FOUNDATION PERMIT

No. **B-20-1945**

RE: TB-20-1945
Morton Ave. (W.S.) 550' N. x Tobey St. (f/k/a #1475 Morton Ave.)
Plot 136A Lot 796
Reviewed 2/19/2021

SHEET NAME:	BUILDING PERMIT PLAN					
PROJECT SITE:	PARCEL 136A-796 (F/KIA #1475) MORTON AVENUE NEW BEDFORD, MASSACHUSETTS					
OWNER INFO:	MARC FREY 350 FAUNCE CORNER ROAD NORTH DARTMOUTH, MA 02747					
DRAWN BY:	DATE:	TEMP	REV.	DATE	DESCRIPTION	BY
DESIGNED BY:	PROJECT NUMBER	JLB	1	11/12/20	REV. HSE, BUFFER, GRADING	JLB
CHECKED BY:	136B-01-01	JLB	2	11/23/20	ADD SEWER, ROOF DRAIN	JLB
	0385-01-01	JLB	3	12/7/20	ADD DETAIL FOR SOIL STORAGE	JLB
		JLB	4	1/18/21	DPI COMMENTS, ADD EX. WATER	JLB
		JLB	5	2/17/21	DPI COMMENTS	JLB
		JLB	6	2/19/21	DPI COMMENT	JLB
APPROVED BY:	SHEET 1 OF 1	JR

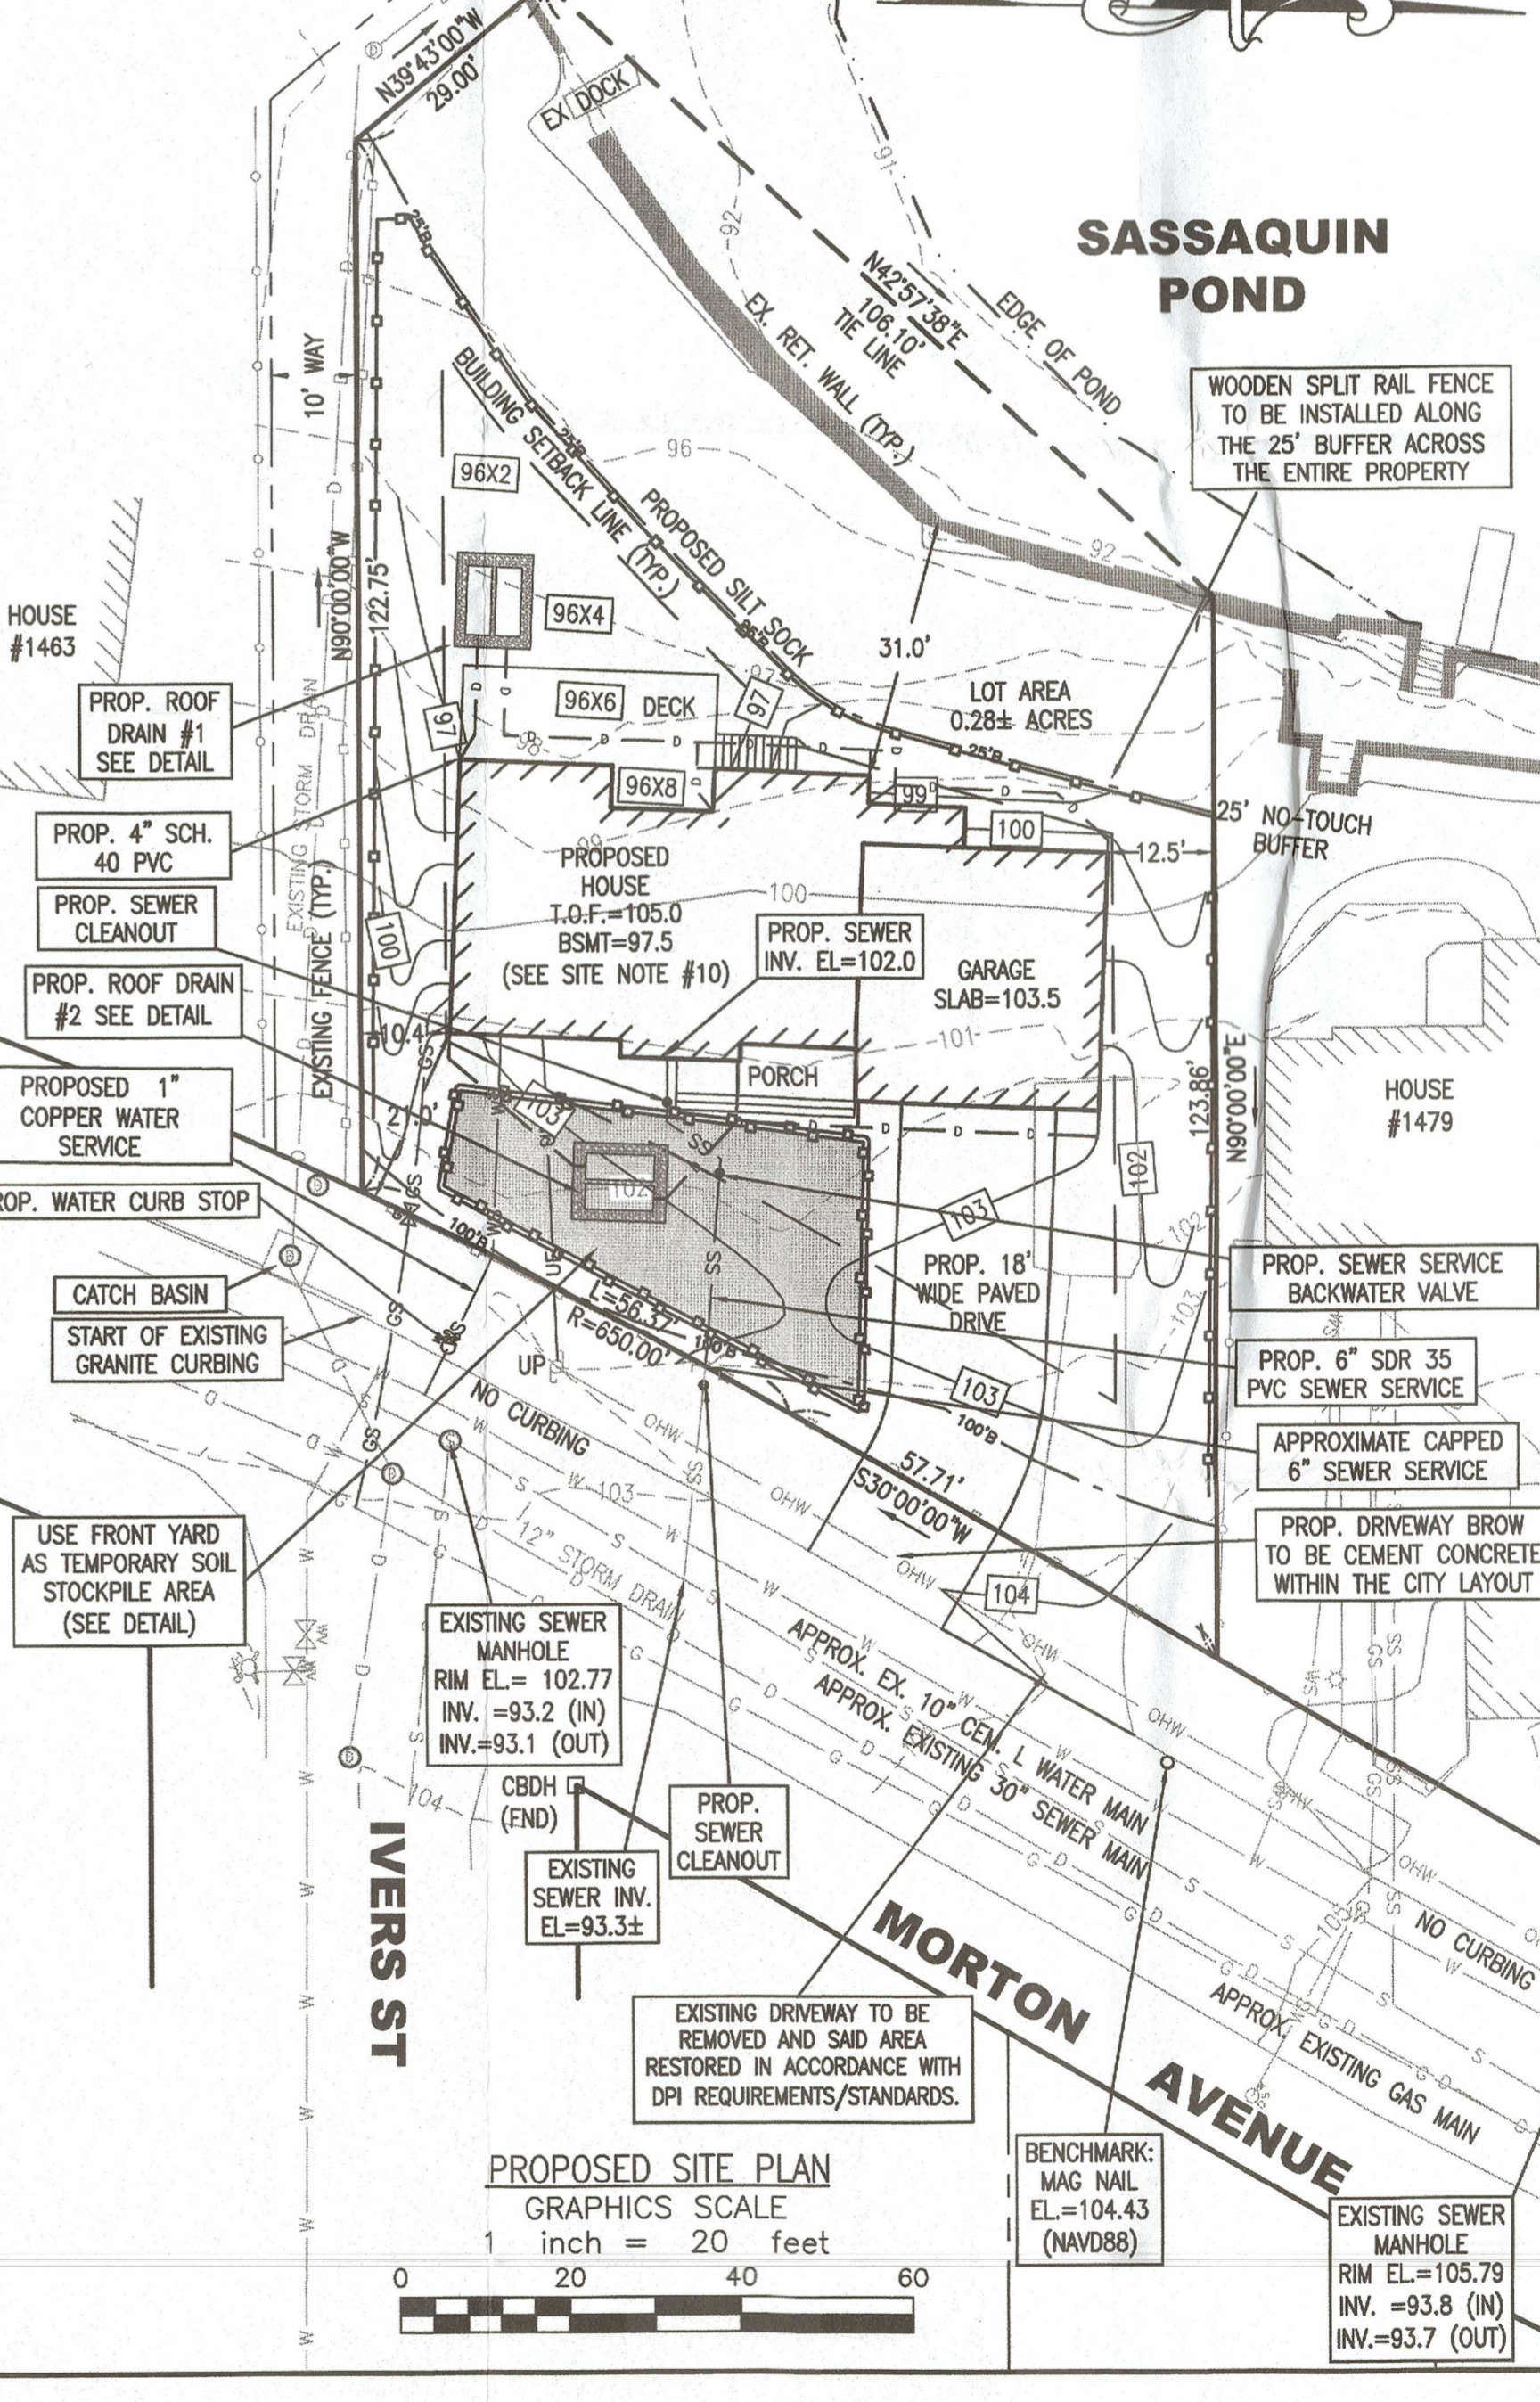
: Applicant needs to have engineered site plan with house, grading, utilities etc including showing the edge of Sassaquin Pond Bank and associated Buffer Zone. Then he needs to file a Notice of Intent with the Conservation Commission and obtain an Order of Conditions before I can sign off with the Building Dept.

- : 1. All unused water services to be cut off at the main.
2. Water service to be perpendicular (90 degrees) from main to inside building.
3. Sewer service to be 10 ft away from water service.
4. Water curb stop (shut -off) to be 1.5ft from face of curb/pavement.
5. Install water meter at point of entry to building
6. revise site plan to show water main and water service connection at main.

1.) The site plan submitted in View Permit, titled: "Building Permit Plan, Parcel 136A-796 (F/k/a #1475), Morton Avenue, New Bedford, Massachusetts", having a date of 10/1/2020 (last revised 2/19/2021), as prepared by Zenith Land Surveyors, LLC and stamped/signed by Jamie L. Bissonnette, P.E. (Civil) and Jonathan J. Pink, P.L.S., was approved for DPI permitting, with the following conditions:

- a. Provide adequate access to utilities that are being proposed to run under new porches, decks, etc. such that said structures do not have to be compromised when maintenance/repair of said utilities is required in the future.
- d. Provide the "final" site plan submitted for DPI permitting (or any modifications approved thereafter) to Inspectional Services to be placed on file in the View Permit system.

The plan recently submitted with a revision date of 1/18/2021 (dated 10/1/2020) is pending being updated to reflect the correct record information and the numerous edits, as discussed in DPI's phone conversations this morning with the surveyor at ZLS (John Pink) and the civil engineer at ZCE (Jamie Bissonnette) regarding DPI requirements and construction specifications/standards.

The following revisions need to be made prior to the permit being approved:

1. The last phone conversation between DPI, the surveyor at ZLS (John Pink) and the civil engineer at ZCE (Jamie Bissonnette) regarding required edits was on 1/29/2021. Yet, the revised site plan that was recently submitted still has a last revision date of 1/18/2021 (dated 10/1/2020), which indicates that it was not updated. Please check that there is an updated revision date on subsequent plan submittals.

2. On the proposed site plan view, please show the area of the existing 12' wide asphalt driveway and add a callout stating that it is to be removed and said area restored in accordance with DPI Requirements/Standards.

3. As was pointed out during DPI's last discussion with the surveyor and the civil engineer, DPI's water records indicate that the portion of the water service being shown as "existing" on the proposed site plan was cut at the tap in 2008 prior to the house formerly known as 1475 being demolished (Since it was a lead service, it could not be reused.) Thus, as requested, please show a new water service installation from the water main to the new house foundation. Please note that the new water service cannot be under the garage slab, so you must choose a point of entry into the house foundation. The portion of the water service within the City Layout must be a straight line, perpendicular to the main and the property line (bends/curves in this portion of the line are not allowed). The new curb stop is required to be 1.5' from the EOP, within the existing "grass" sidewalk area.

The plan recently submitted in View Permit is a building permit plan (dated 10/1/2020) and does not contain the information required for DPI to conduct a proper review of the site. The company that prepared the plan, ZLS, should refer to the final site plans that it submitted to DPI for similar projects (i.e. Bryant Ln., Almy St., etc.) for guidance and update this plan accordingly if it is to be utilized as the site plan. All proposed work that falls under DPI jurisdiction is to be shown and meet DPI requirements and construction specifications/standards.

The following is a quick checklist of the elements that need to be incorporated into the site plan to be submitted for review by DPI:

1. Please check that all existing site conditions are shown (i.e. buildings, utilities, mains/service connections, shut offs, clean outs, septic system (if any), driveways/sidewalks, curb/berm or edge of pavement, grading, etc.) and properly labeled (i.e. size/type of existing mains, services, type of curb/berm, etc.).

2. Clearly depict and properly label all proposed work (i.e. new structure(s), water/sewer/storm drain mains/service connections or septic system, driveway(s)-new/closure/widening, storm recharge system for roof runoff/calculations/details, grading, etc.). Ascertain everything is properly called out (i.e. proposed 1" copper water service, proposed 18' wide asphalt driveway apron, etc.).

3. Check with DPI to obtain the record information for the existing water/sewer mains within the ROW and services to said property, and update accordingly.

4. Check City of New Bedford Stormwater regulations and ordinances and ascertain that compliance has been met.
5. Check that the site plan being submitted has been stamped/signed by the professional engineer responsible for the site development/infiltration system design and by the surveyor responsible for the field survey (if any).

6. *Please do not reference the address of the structure that was razed (#1475 Morton Ave.) in the site plan title for a new building. For example, the title should reference the street name and the parcel id., and state "(f/k/a #1475 Morton Ave.)". The new building does not automatically assume the address of the structure that was previously on the lot.
